**Submission of Further Information (FI)**

**Temporary Shop and Services (Retail Shop for Hardware Groceries and Construction Materials) with Ancillary Facilities for a Period of 5 Years in “Residential (Group D)” Zone, Lots 670 (Part), 671 (Part), 673 (Part), 674, 675, 676, 677 (Part), 679 (Part) and 680(Part) in D.D. 106 and Adjoining Government Land, Yuen Long, New Territories (Application No. A/YL-KTS/1101)**

**Further Information for Planning Application No. A/YL-KTS/1101****Response-to-Comments****Comments from Commissioner for Transport**

Plan 5.1a  
( P 22068A )

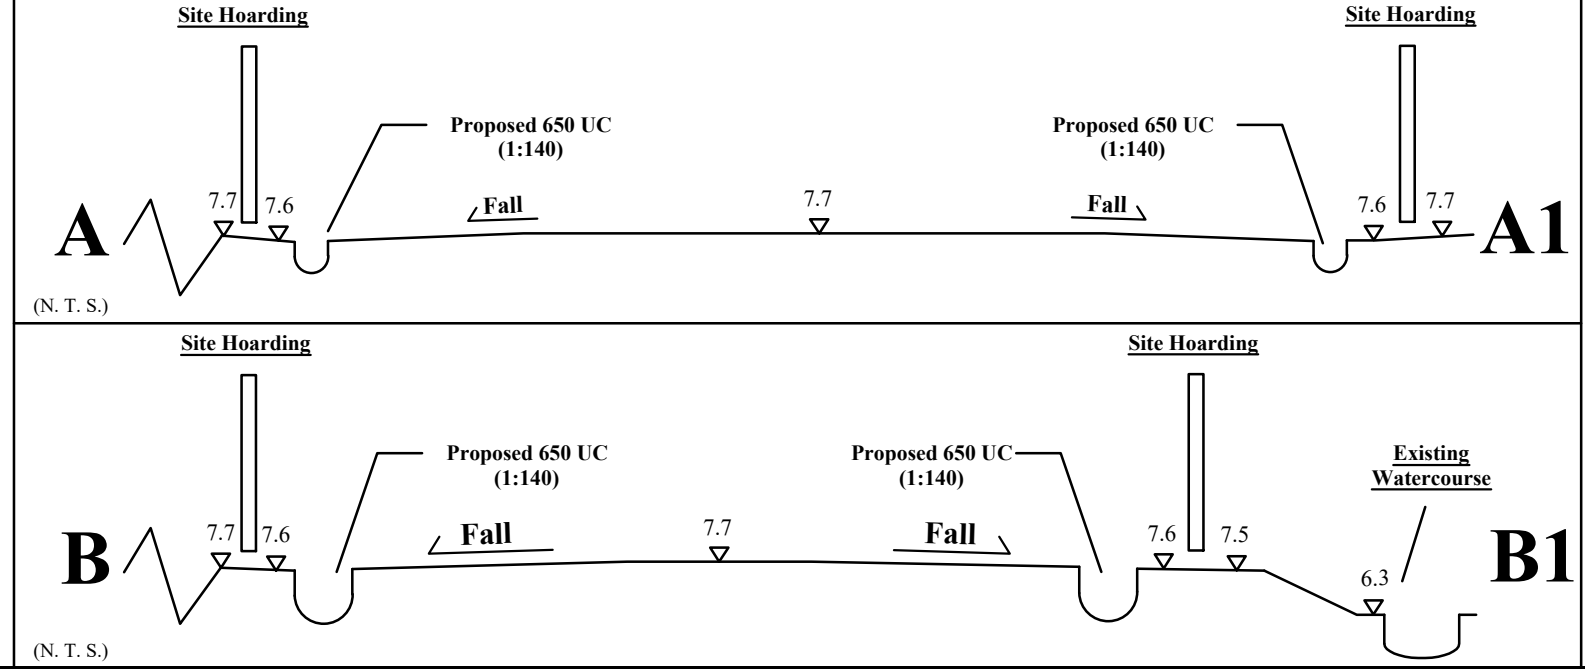
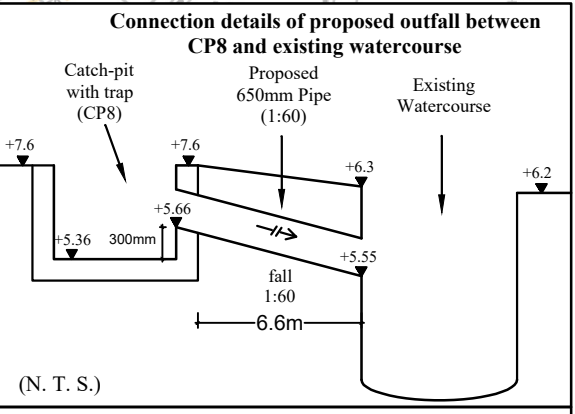
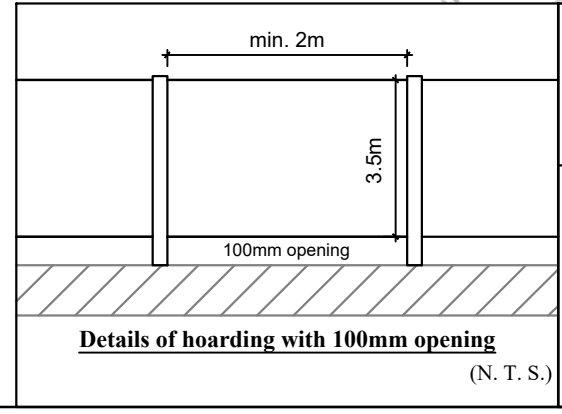
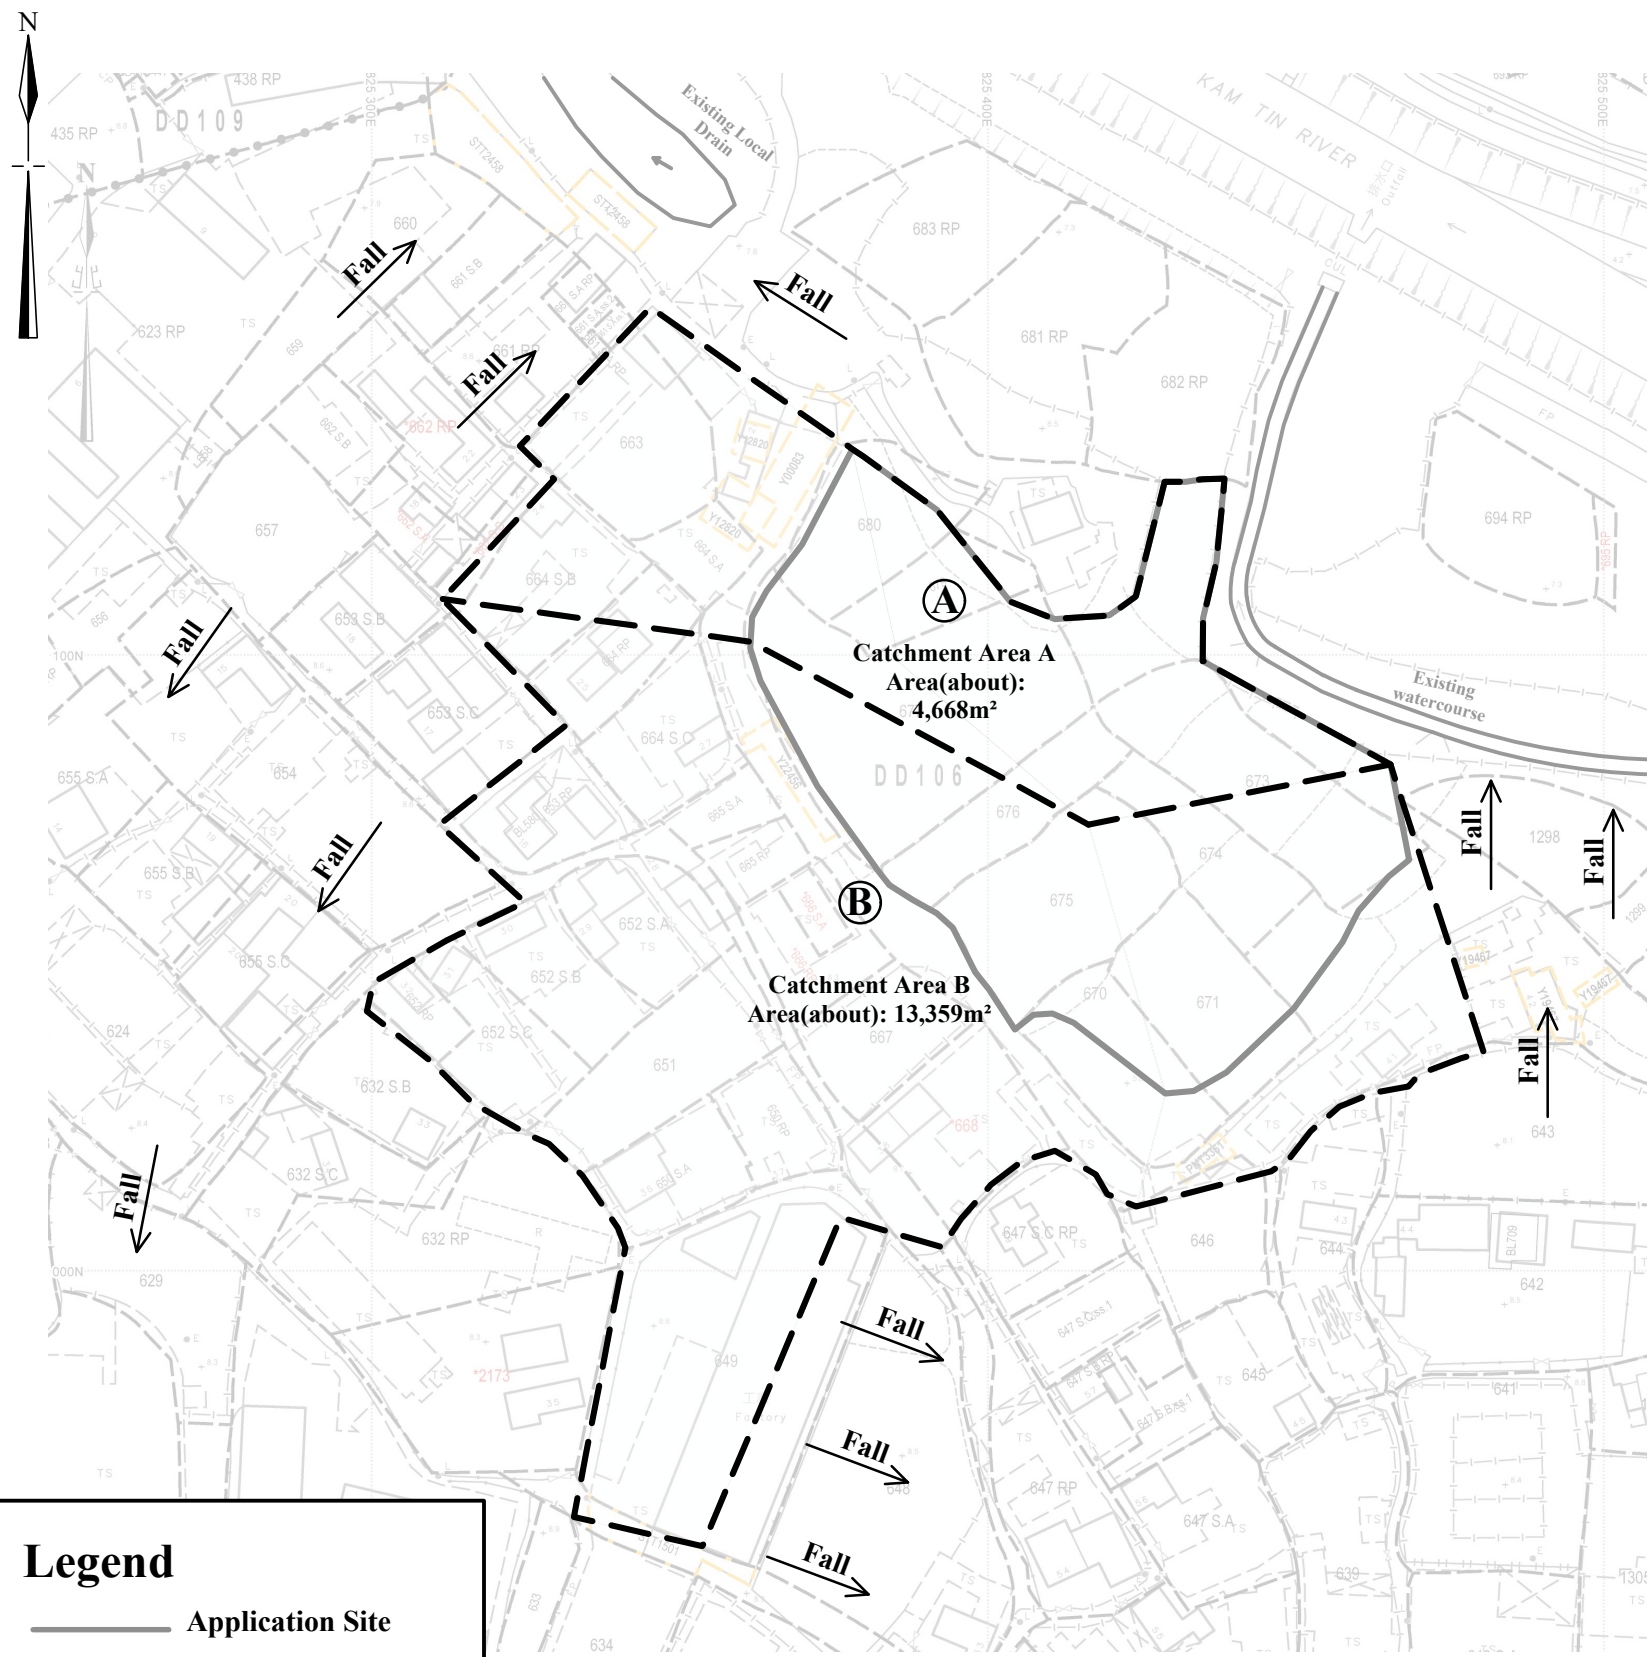
<b>III.</b>	<b>Comments</b>	<b>Responses</b>
1.	The proposed connection details at both discharge points with L-shape downpipe as shown on drainage plan (Plan 5.1a) is not typical arrangement. Please review the details of the proposed discharge connection accordingly.	The details of the proposed discharge connection are reviewed. Please refer to Plan 5.1a.

2.	Referring to the connection details in Plan 5.1a, the ground level at the bank of the existing DSD's channel at both sides should be similar. In this regard, the proposed invert level at both discharge points will be higher than the existing ground level, please review.	The proposed invert level at the discharge points is reviewed. Please refer to Plan 5.1a.

3.	In general, only one terminal manhole/last catchpit with sand trap will be provided for each development. Please review.	The number of last catchpits for the development is revised to one last catchpit only. Please refer to Plan 5.1a.

5.	According to R-to-C, it is noted that no site formation/levelling works to be carried out under this application. Please state the above on the drainage plan (Plan 5.1a) for record.	Noted. Please refer to Plan 5.1a.

6.	To improve the drainage performance, please consider increasing the size of the proposed 400mm discharge pipes and peripheral surface channels accordingly.	The discharge pipe after the last catchpit will be upgrade to 650mm pipe. Please refer to Plan 5.1a.

**Note: No site formation/levelling works to be carried out under this application. Thus, the existing ground levels is equal to the proposed ground levels.**

<b>1:1000 (A4)</b>	<b>Layout Plan</b>	<b>Goldrich Planners &amp; Surveyors Ltd.</b>
<b>April 2026</b>	Lots 670(part), 671(part), 673(part), 674, 675, 676, 677(part), 679(part) and 680(part) in DD.106 and adjoining Government Land	<b>Plan 3a ( P 22068A)</b>

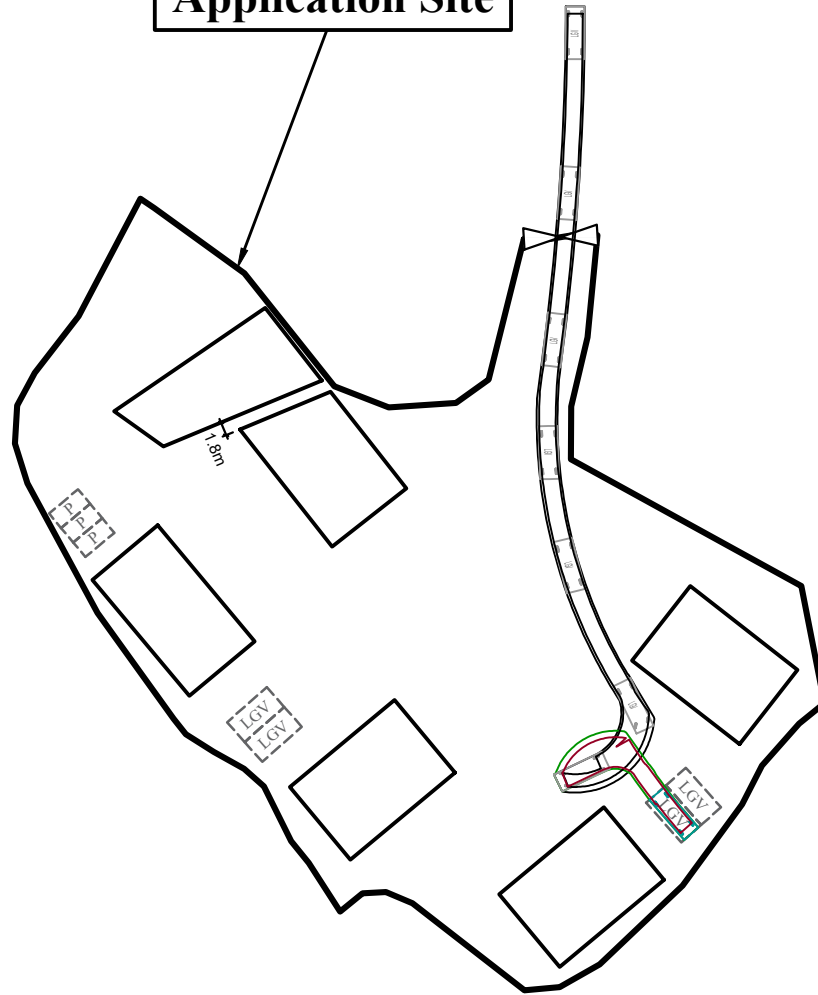
<b>II.</b>	<b>Comments</b>	<b>Responses</b>
1.	Based on the applicant's submission, the proposed use would not involve dusty operation but it would cause traffic of heavy vehicles (i.e. medium goods vehicles). According to our review, there are residential structures within 100m from the boundary of the Site. As such, according to the revised 'CoP', it is anticipated that the proposed use would cause environmental nuisance to the residential structures nearby. Therefore, we do not support the application from environmental planning perspective.	Light goods vehicles instead of medium goods vehicles will be adopted for the daily operation of the Proposed Development. Please refer to the revised Layout Plan (Plan 3a) for details.
